City of Alexandria, Virginia

SUBJECT: CONSIDERATION OF STAFF REPORT ON THE NATIONAL PARK
SERVICE JONES POINT PARK REPORT AND THEIR SCHEDULE FOR
RECEIPT OF COMMENTS

DRAFT REPORT ON THE NATIONAL PARK SERVICE JONES POINT PARK 2006 ENVIRONMENTAL ASSESSMENT ALTERNATIVE 1 AND ALTERNATIVE 4

Attachment b

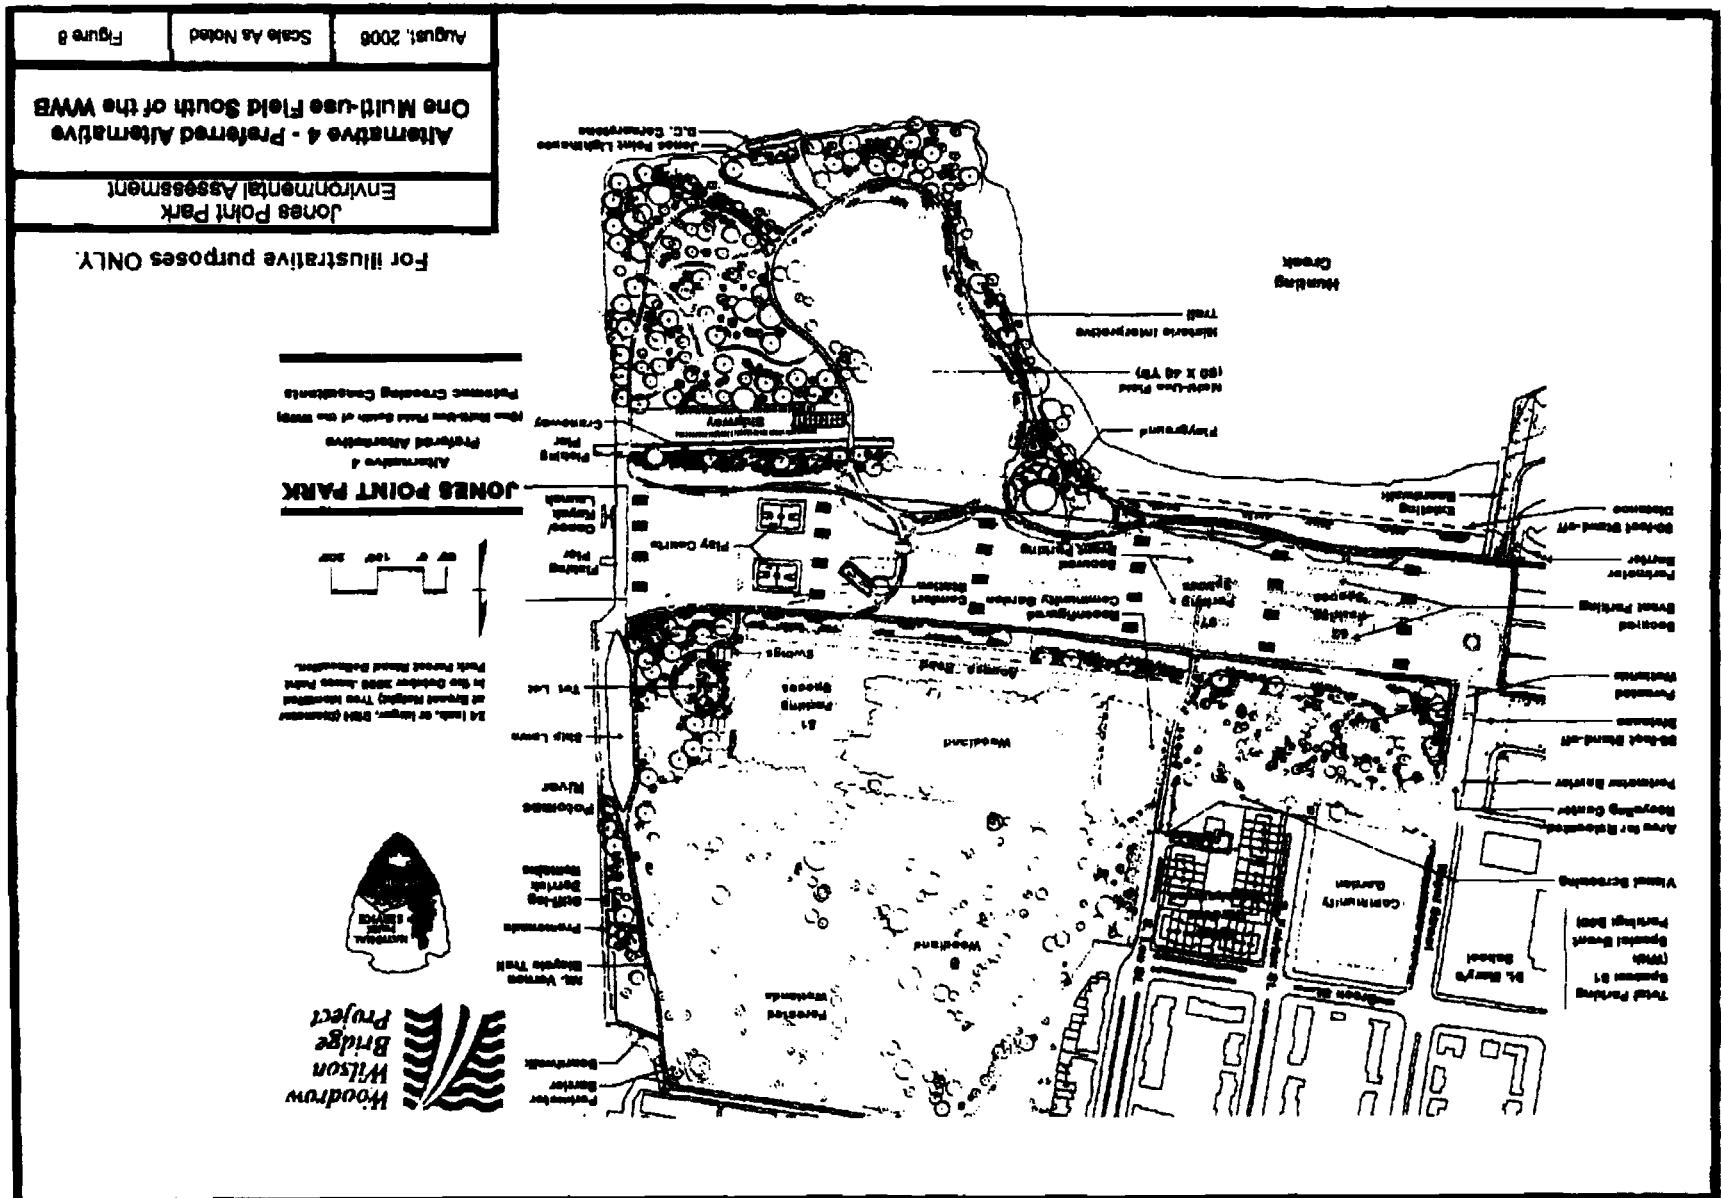
NPS PREFERRED ALTERNATIVE: The Alternative 4 - NPS Preferred Alternative- One Multi-Use Field South of the WWB includes the following elements:

- One small 80 yards x 40 yards field, south of the Bridge
- An 81 space parking lot located within the current gravel parking lot area, close to the tot lot, ship lawn and fishing pier
- Historical preservation of the Shipway
- Interpretive areas and trails
- Fishing piers and riverfront access for pedestrians
- Event Lawn with active use
- Play Grounds
- Multiple play courts
- Natural resource areas
- Park trails and trail connections to Mt. Vernon Trail
- Jones Point Lighthouse
- Park Office and comfort station
- Reconfigured community gardens
- Special Event parking (159 spaces) under the Bridge

Alternative 4 contains one 80 yards x 40 yards south of the bridge located in the Event Lawn/Historic Interpretive area. The Event Lawn becomes a multi-functional athletic area. Approximately 15,680 square feet of wetlands will be impacted by this layout as the access road crosses two delineated areas, as well as up to 1 or more trees greater than 24 inches. A smaller forested area, approximately 2.7 acres within the park, currently overrun by invasive plant material, will be impacted by the layout. As noted above, according to the JPP EA06, there will be little effect on soils as the grading activities will result in the placement of clean fill material on top of existing soils, which would leave the existing soils intact.

In NPS Alternative 4, the parking is shown significantly east of Lee Street and creates a impervious surface closer to the river front than the City's recommended Alternative 1. Alternative 4 provides for fewer parking spaces (29) and locates them further from the proposed small field. It should be noted that within the City's recommended alternative, that the NPS Alternative parking area would have been pervious playing field area which would have continued the green open space near the river. The City's Alternative requires less vehicular traffic through the park.

The City's recommendation, Alternative 1, does not impact the historical and archeological areas within the park due to the location of the multi-use fields. With the field located south of the bridge in the NPS preferred alternative, this plan does not provide a relaxed, interpretive and contemplative environment for those historical and archeological areas.
